Appendix G: RFLMA Contact Records

**ROCKY FLATS SITE
REGULATORY CONTACT RECORD**

Purpose: Phase II and III Upgrades to Solar Ponds Plume Treatment System

Contact Record Approval Date: February 17, 2009

RFLMA CR 2009-01 Figure 3: Section of plan-view schematic drawing (at 30% design) showing proposed components of Phases II and III to left of existing treatment cells.

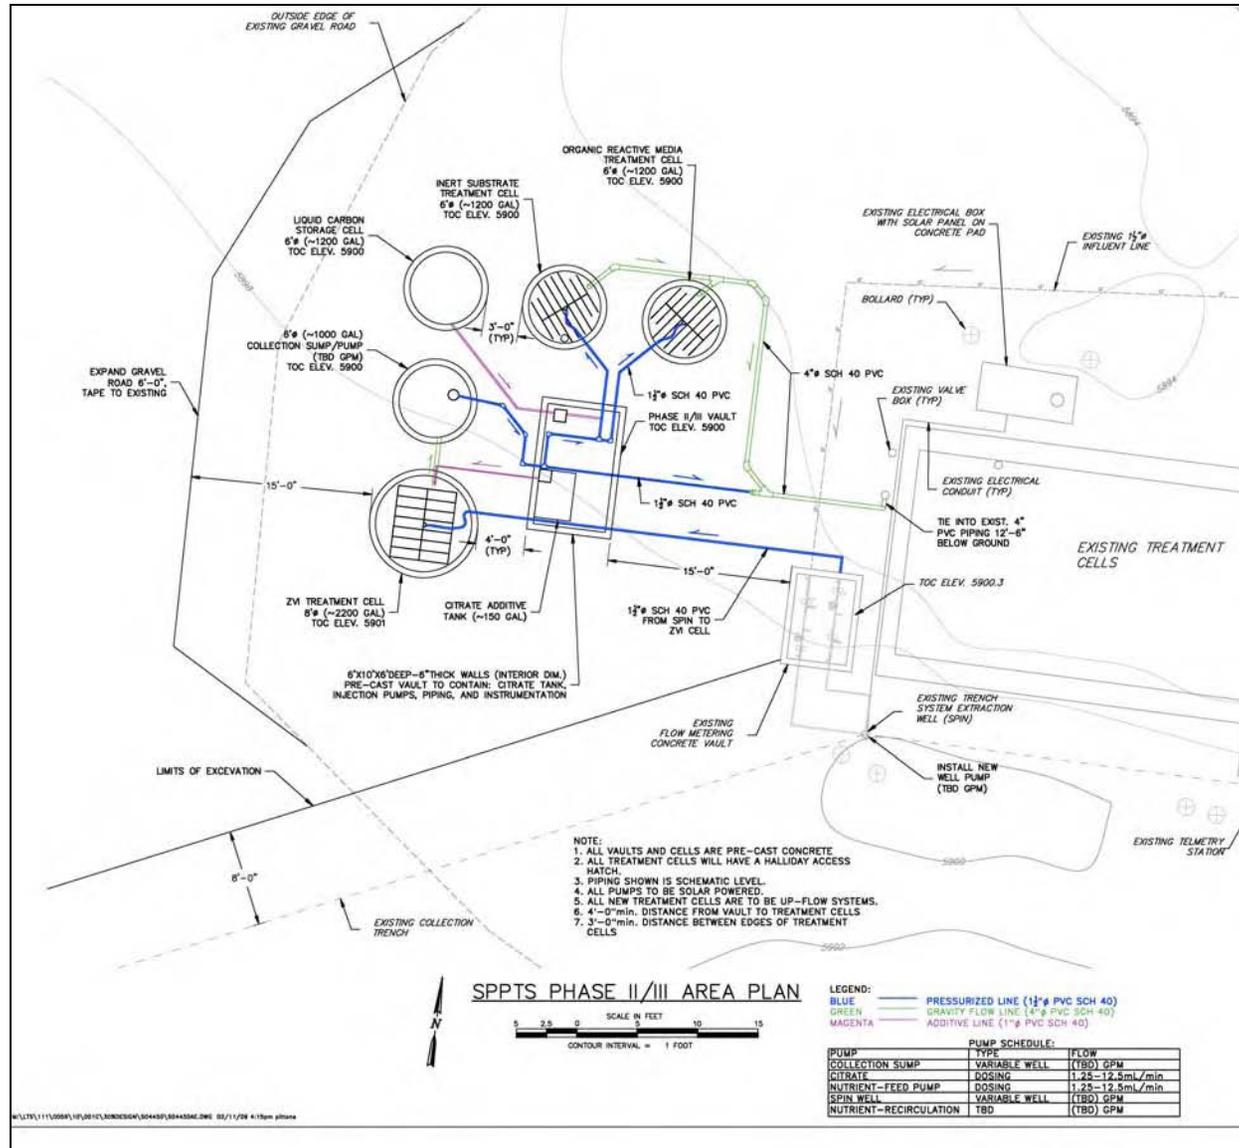
The conceptual design for Phases II and III is included in Figure 3. The construction involves excavation prohibited by the institutional controls (ICs) incorporated in RFLMA. The excavation work will exceed the 3-foot-depth limit specified by ICs (RFLMA, Attachment 2, Table 4, Control 2 [IC 2]) and thus requires pre-approved procedures. Specifically, this work will entail excavation to maximum excavation depths of approximately 10 feet below ground surface (10 ft. bgs) for most of the construction, with new pipe connections made at the influent to existing Cell 1 at a depth of approximately 15 ft. bgs.

Resolution: The installation of the SPPTS Phase II and Phase III upgrades will be conducted as described in this Contact Record. The tracer test plan will also be provided to CDPHE.

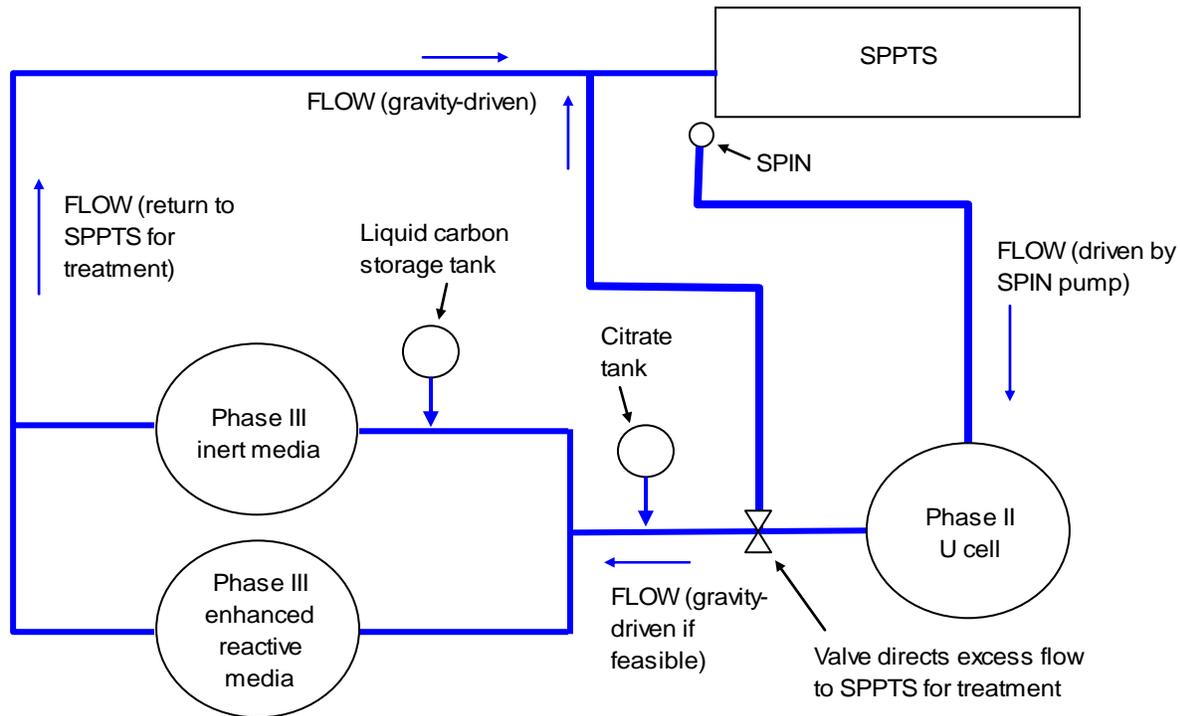
Pilot testing of the preferred treatment approaches will be conducted in two approximately 1,000-gallon subsurface concrete treatment cells installed downgradient from the (Phase II) uranium treatment cell scheduled to be installed in March 2009. One cell will contain an enhanced reactive media consisting of walnut shells combined with food-grade vegetable oil. The second cell will contain an inert media consisting of the Honeywell polyurethane foam blocks and plastic cylinders, and supplemented with a 15% ethanol solution from the MillerCoors brewery (or other suitable organic carbon source pending final results of bench-scale testing and analysis).

Both treatment systems will be configured and plumbed to operate in an upflow mode while receiving effluent from the uranium treatment cell via a gravity flow. However, depending on the final location and design, one or more small, solar-powered pumps may be required to overcome head loss. Influent rates will vary as biofilms evolve in each system; once steady-state conditions have been established, flow will be continually increased until breakthrough is observed and a minimal HRT can be determined.

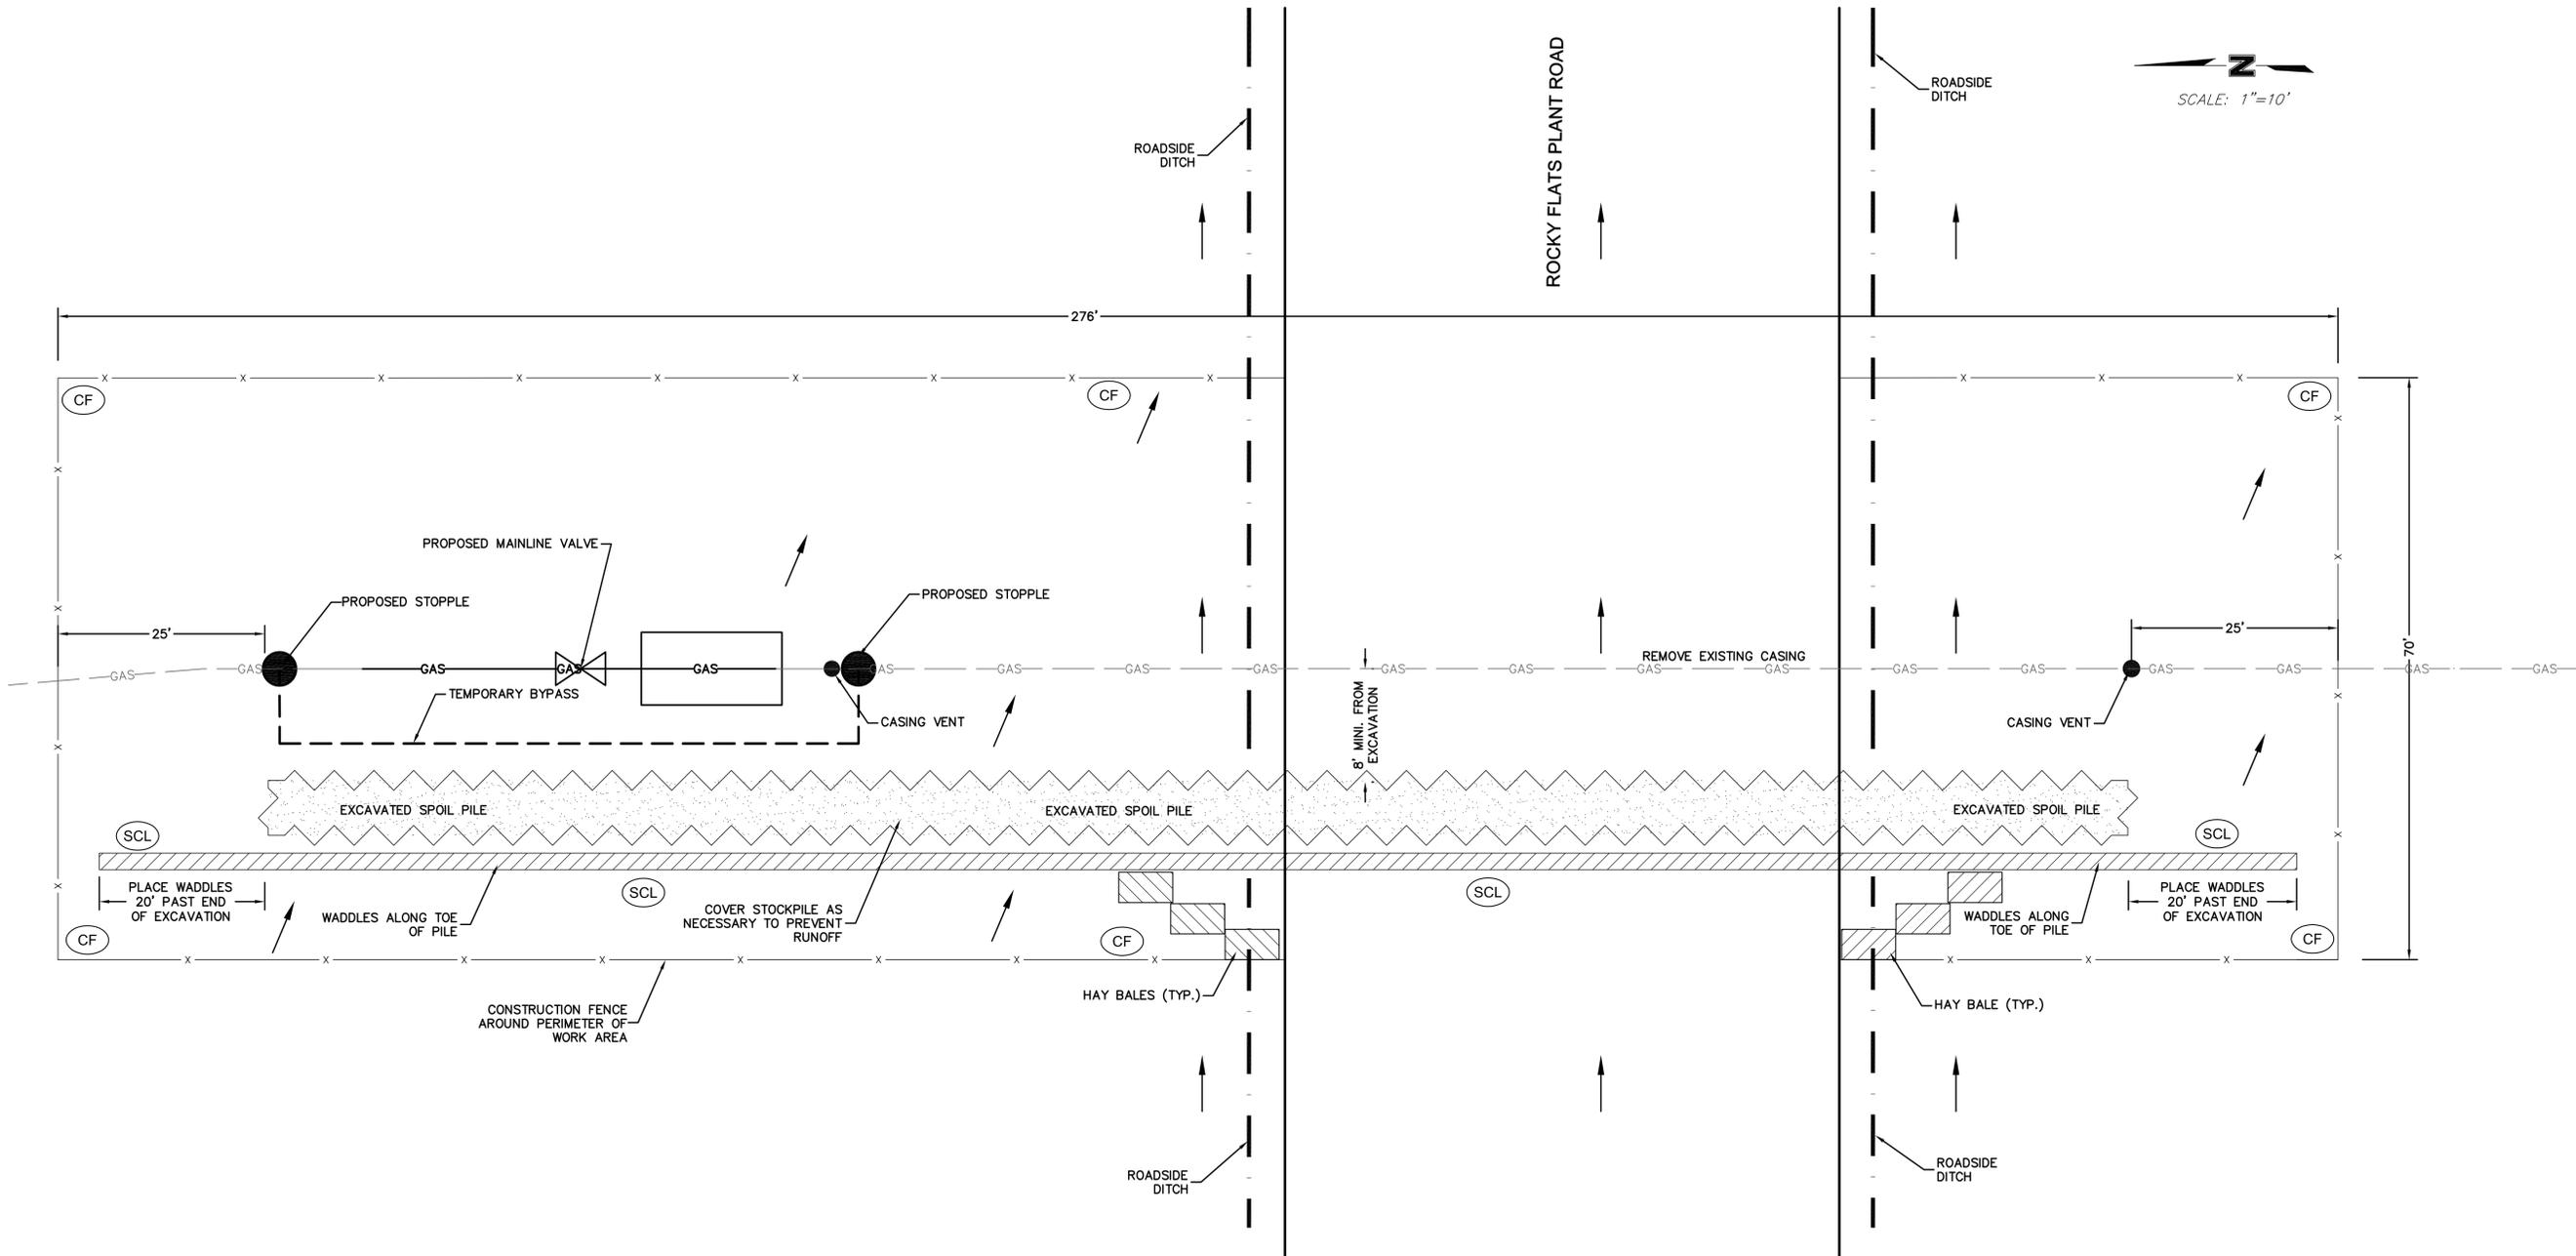
2. The construction site is shown on Figure 1 (attached).
3. The pipeline is reportedly buried at a depth of approximately six feet below ground surface (bgs). It is expected that the excavation would be less than six feet wide and the base of the excavation would be less than 10 feet bgs. Trench boxes would be used to stabilize the side walls of the trench and minimize the area of disturbance.
